RCARS Pavilion

ADDENDUM # 1

9/22/2023

Addendum items

Wall Types

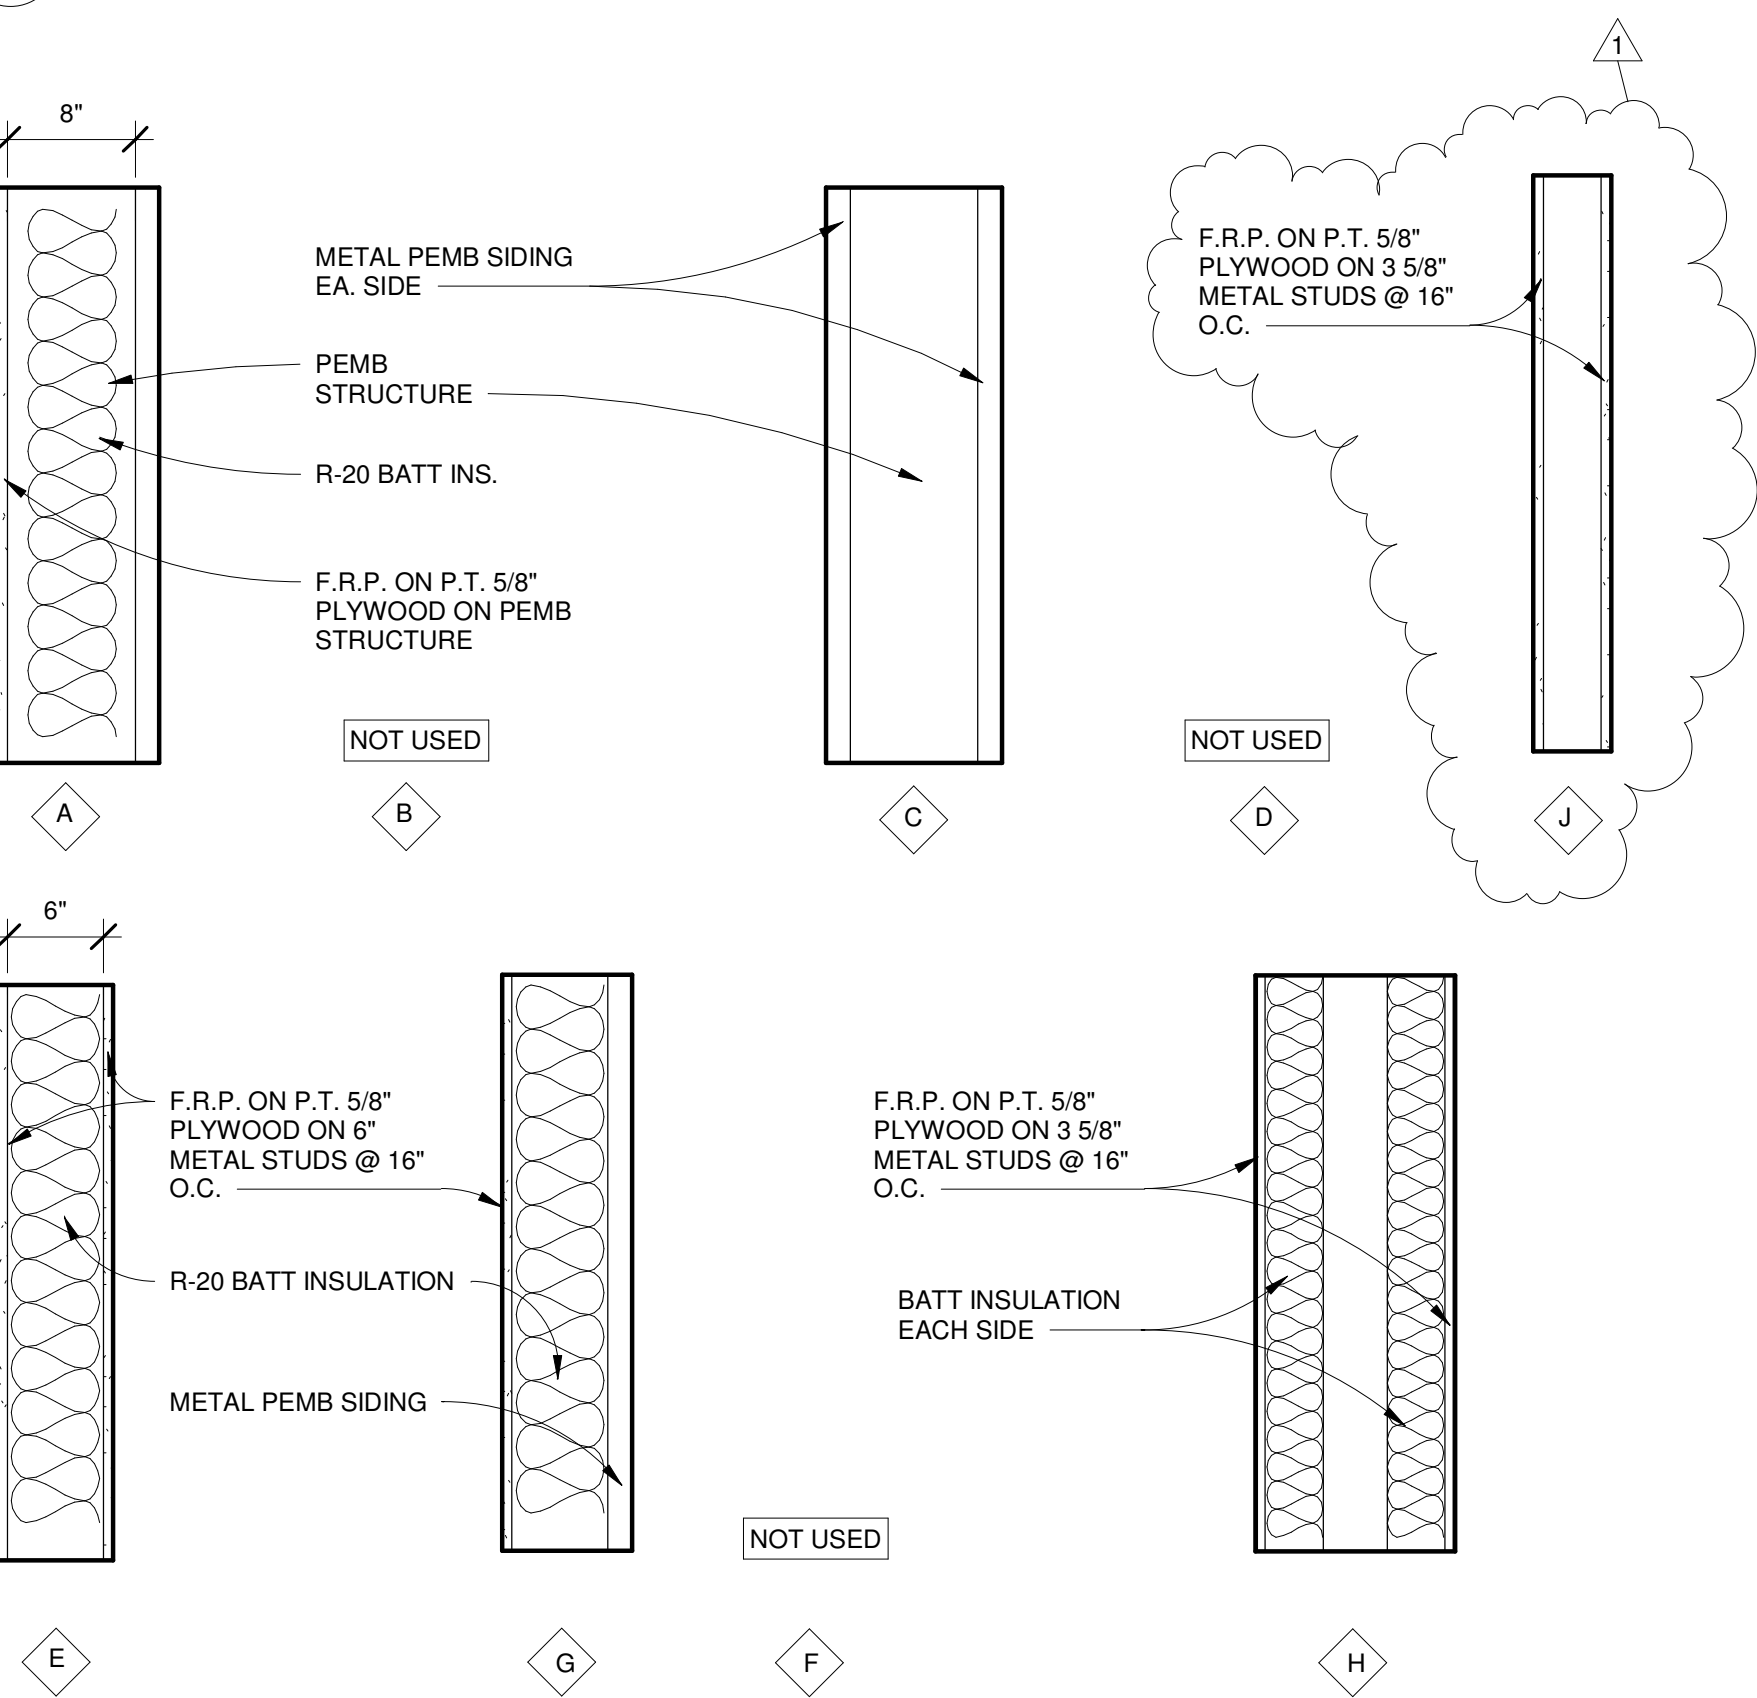
Wall type "J" has been added to pavilion in lieu of "D" on plans, located in restroom area. Wall type "d" is using a 3 5/8" metal stud while wall type "E" is using a 6" metal stud.

Floor Plan

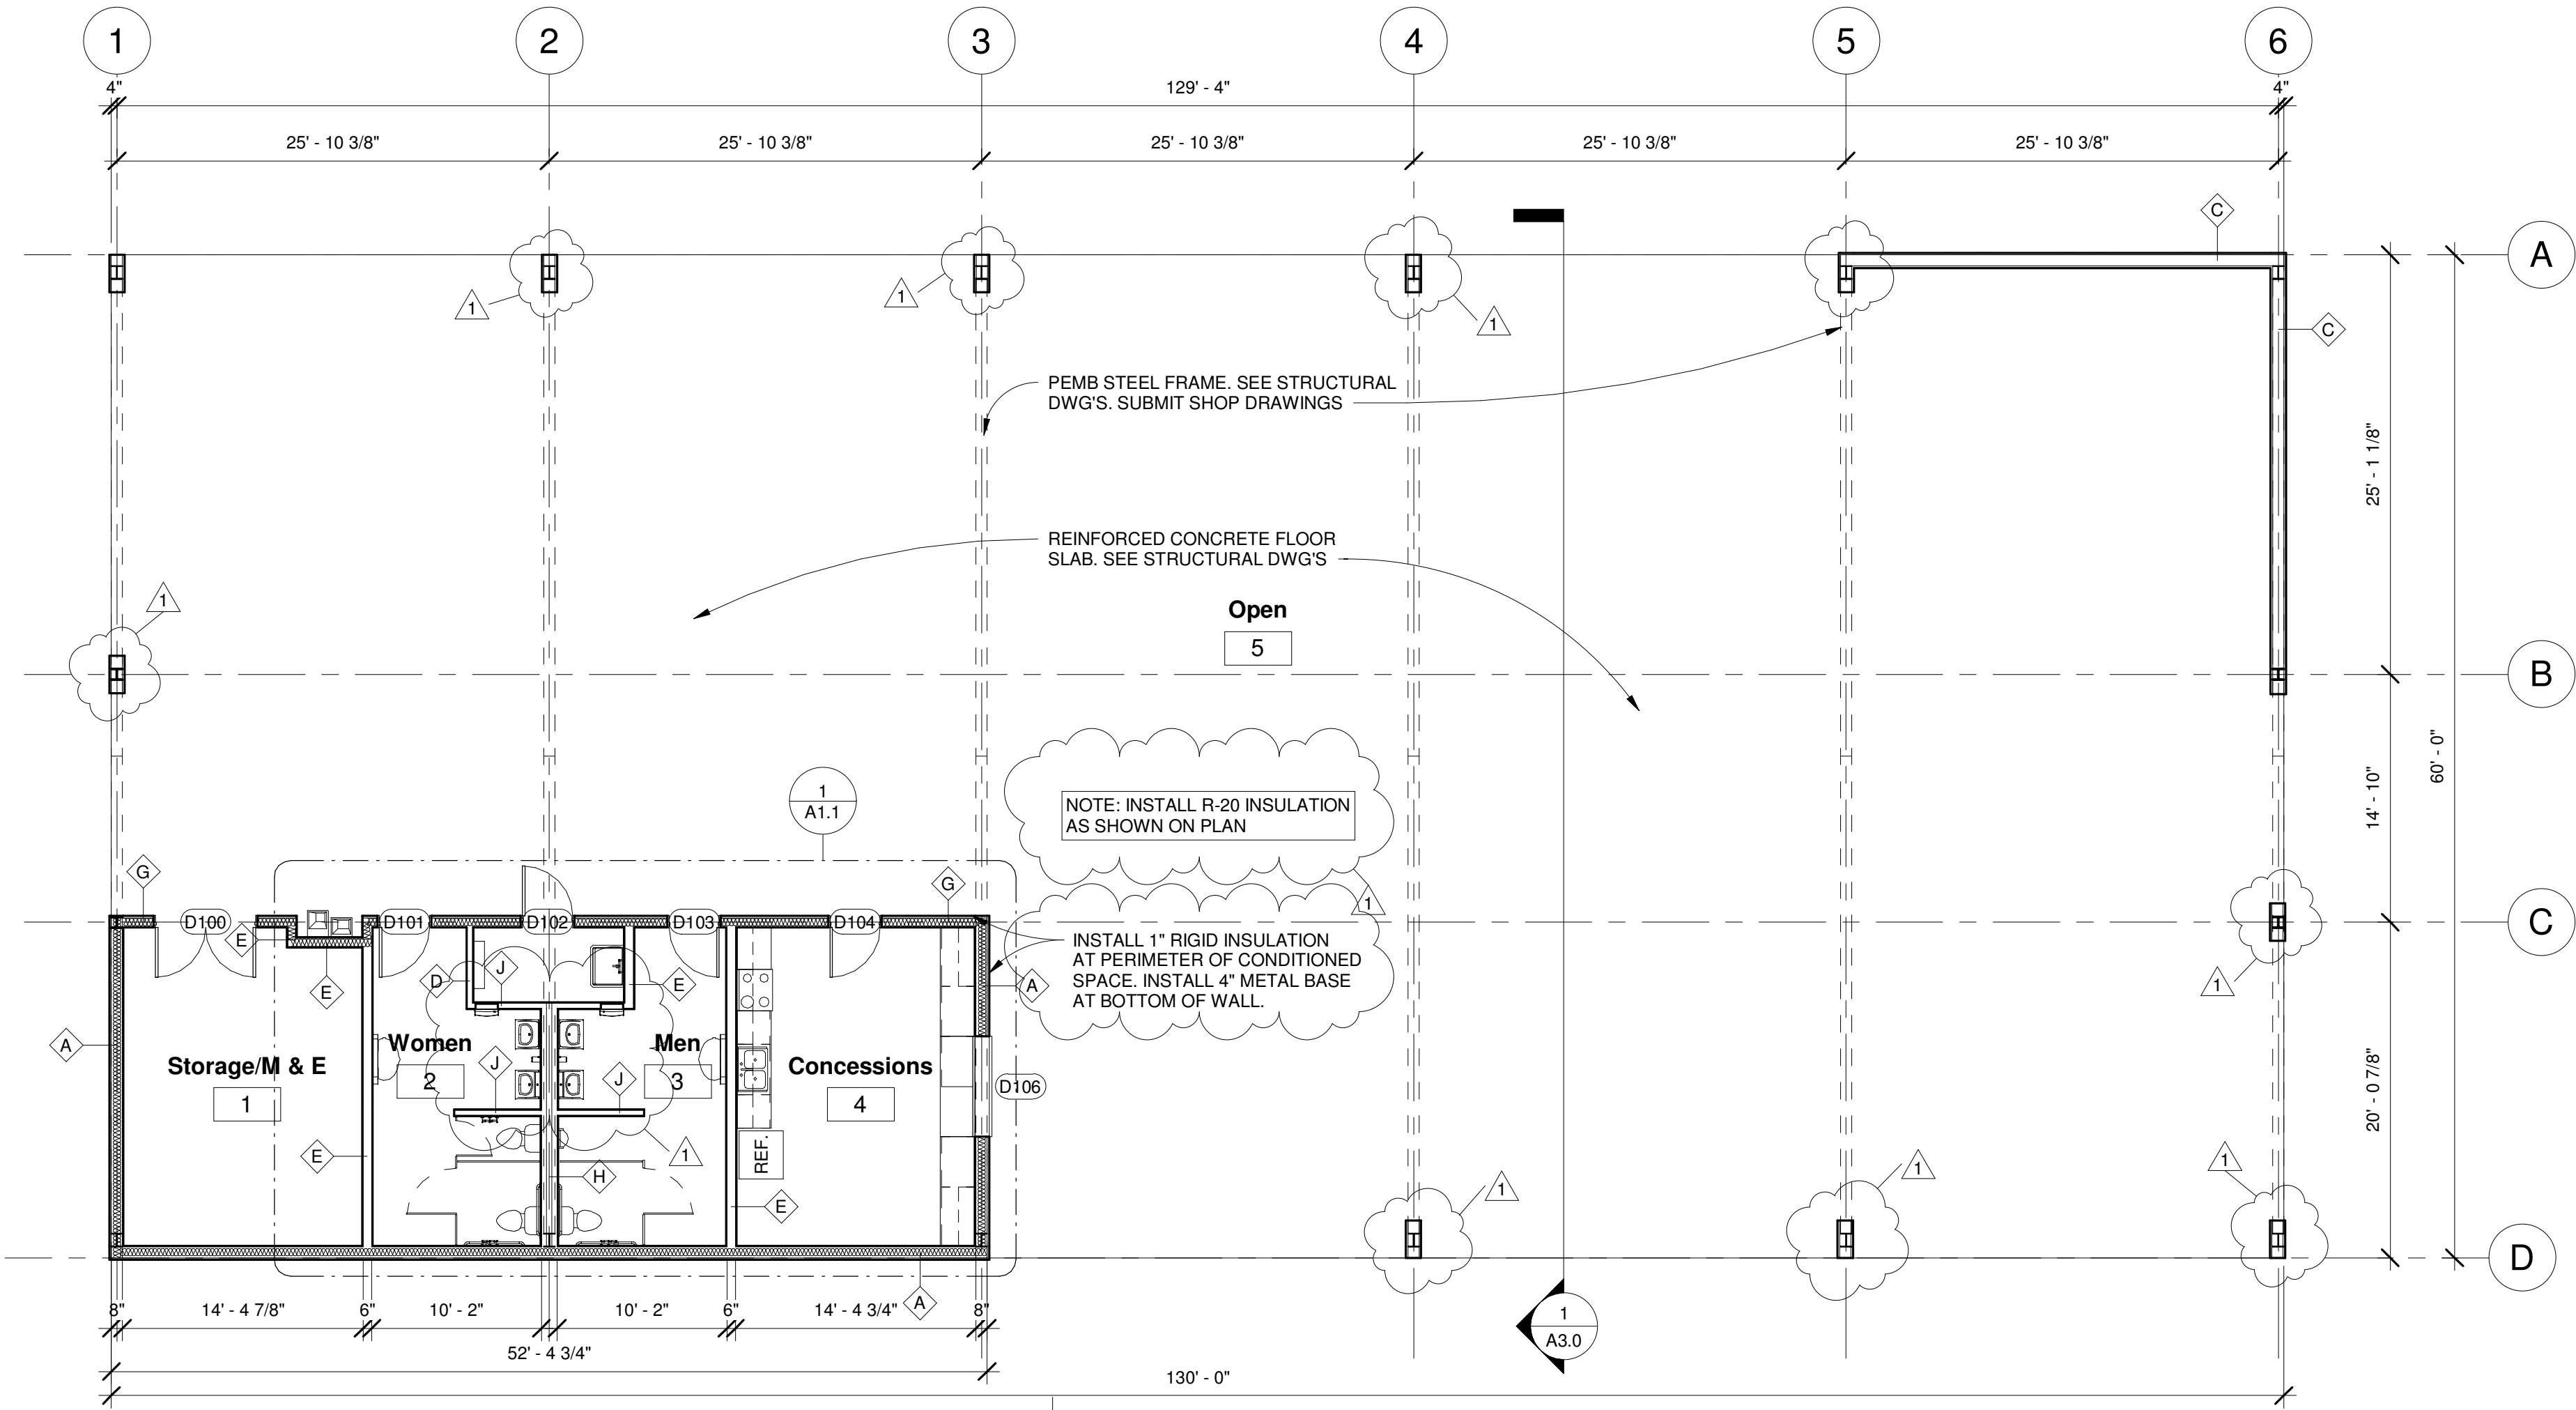
The building sidewall columns shall be straight to 9'-0" then may taper. Install metal wall surround at steel columns from floor to structure above. Do not surround the sloped section of the columns. See revised plans and elevations.

(5) Rake Detail
1" = 1' - 0"

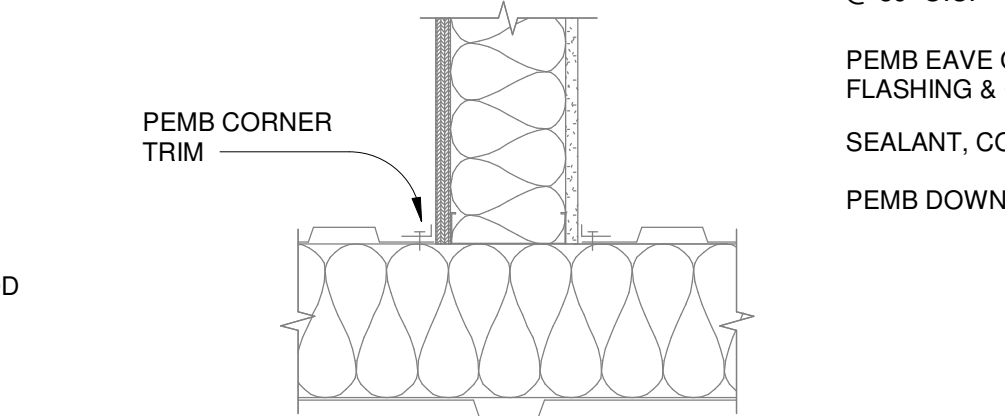
Remove the 12" roof overhang at rake and soffit. Use details 5 & 9 on sheet A3.0.

A0.0 FINISH GRADING (updated 9/20/23)

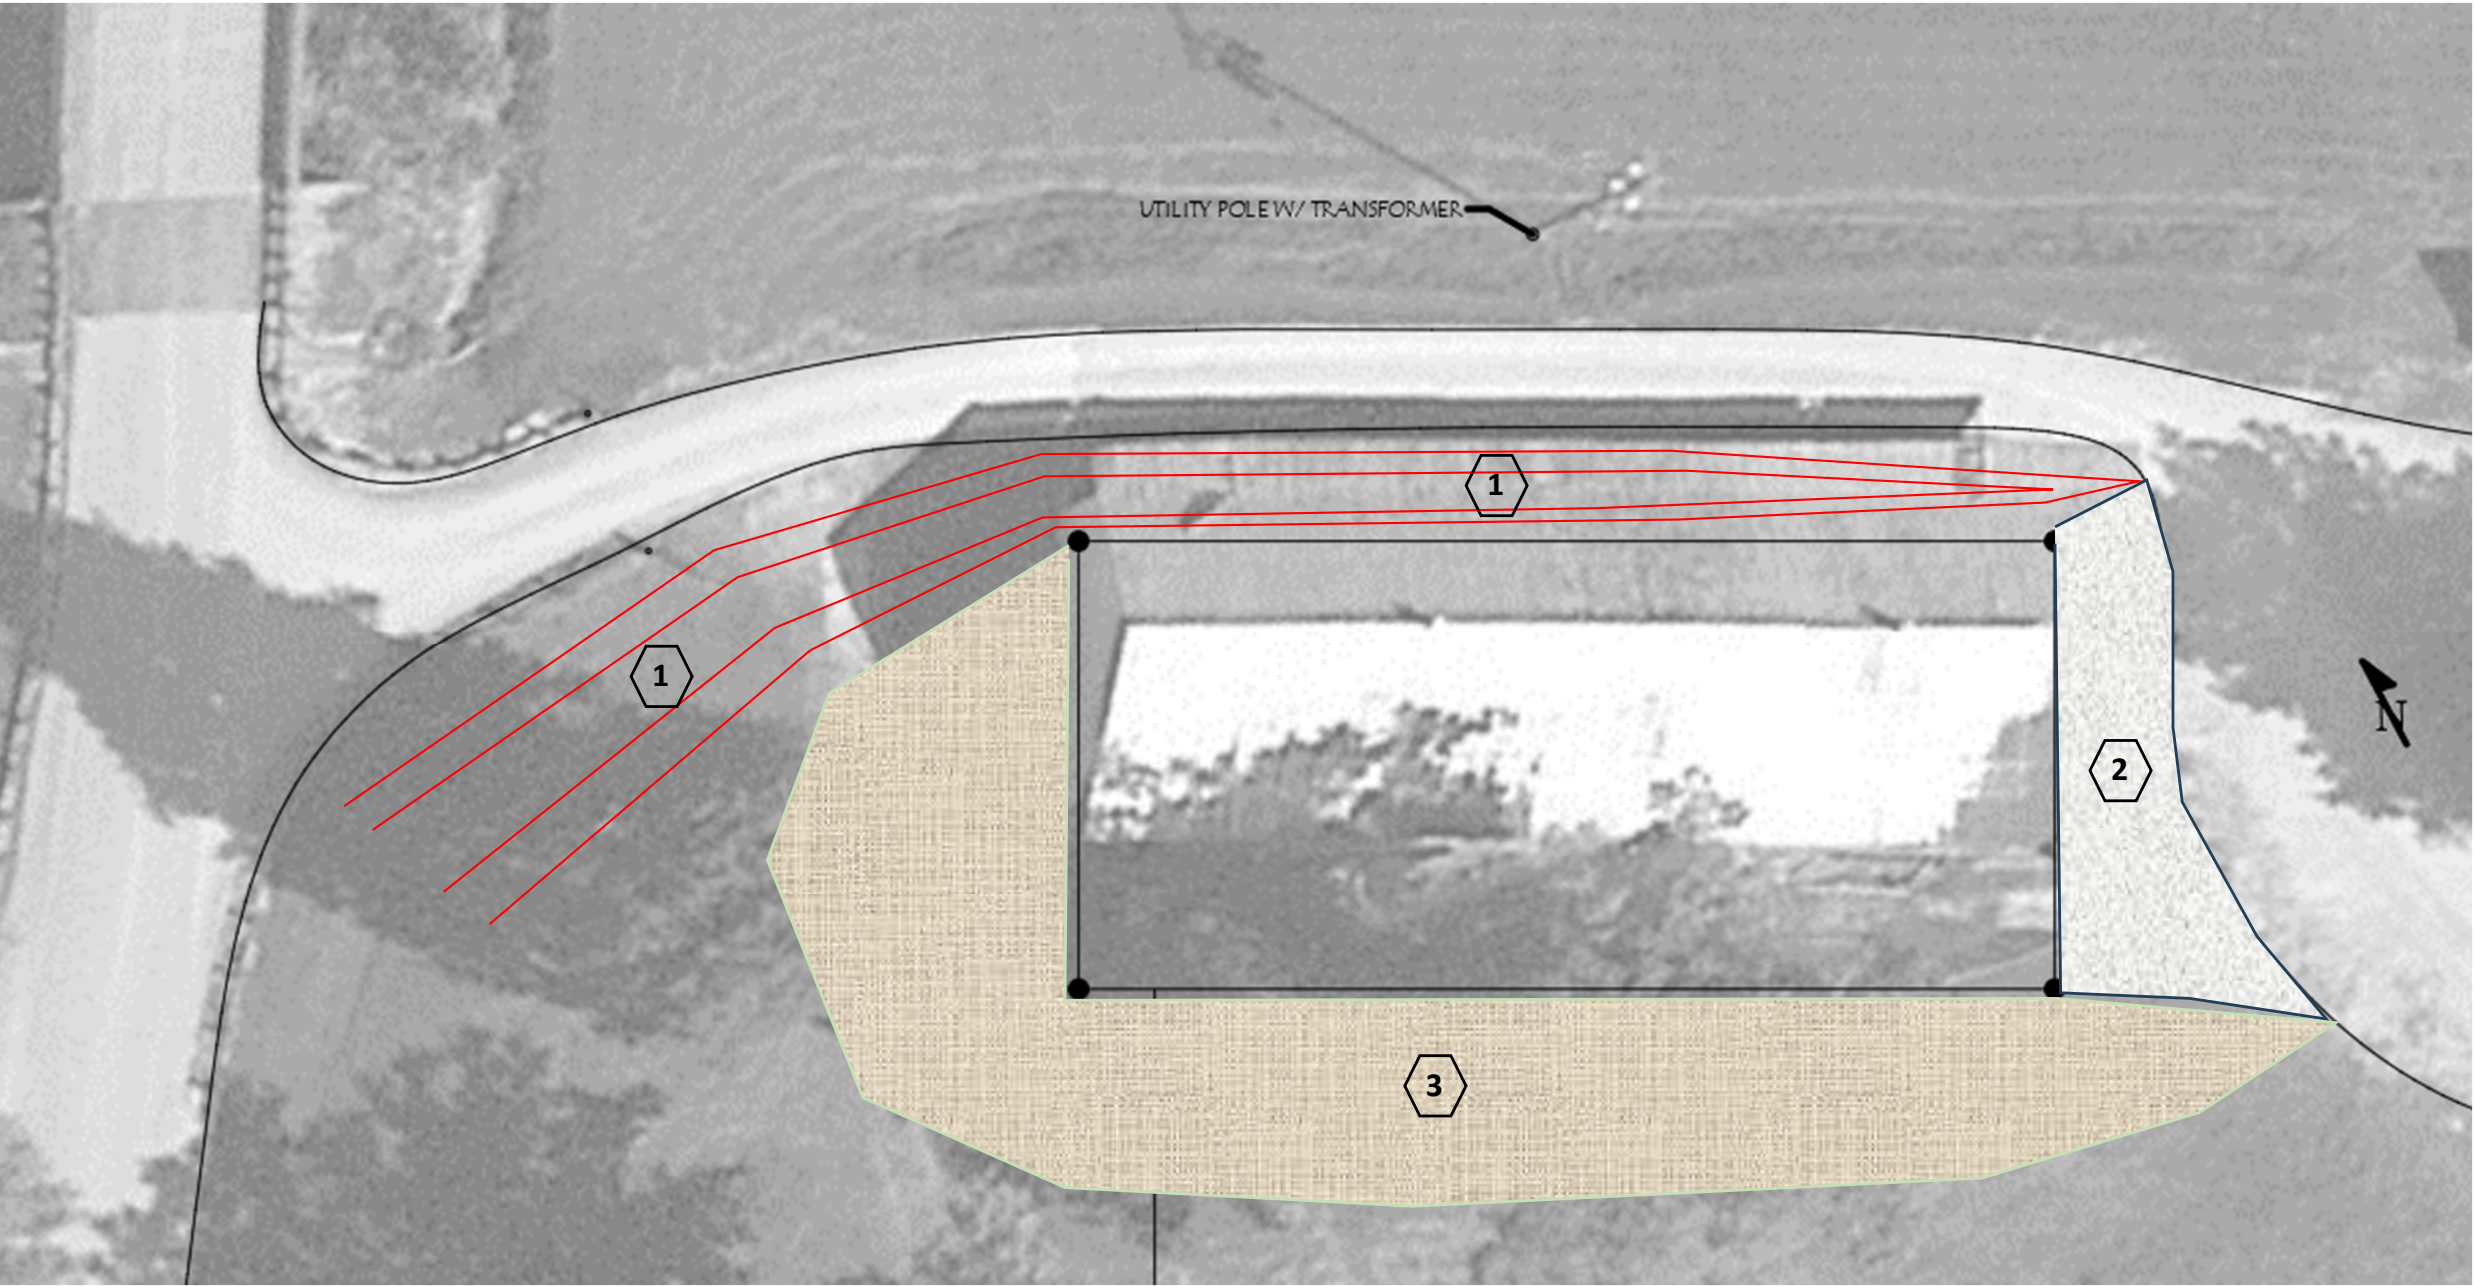
- 1 DRAINAGE SWALE BETWEEN GRAVEL DRIVE AND BUILDING
- 2 SLOPED FILL WITH COMPACTED GRAVEL CONNECTING BUILDING WITH EXISTING GRAVEL DRIVE
- BASIS OF DESIGN = 100 CUBIC YARDS OF COMPACTED STONE/GRAVEL OVER GEOTECTILE FABRIC**
- 3 SLOPED TOPSOIL FILL FROM BUILDING PAD. BLEND INTO EXISTING LAWN. SEED & STRAW.
- BASIS OF DESIGN = 300 CUBIC YARDS**
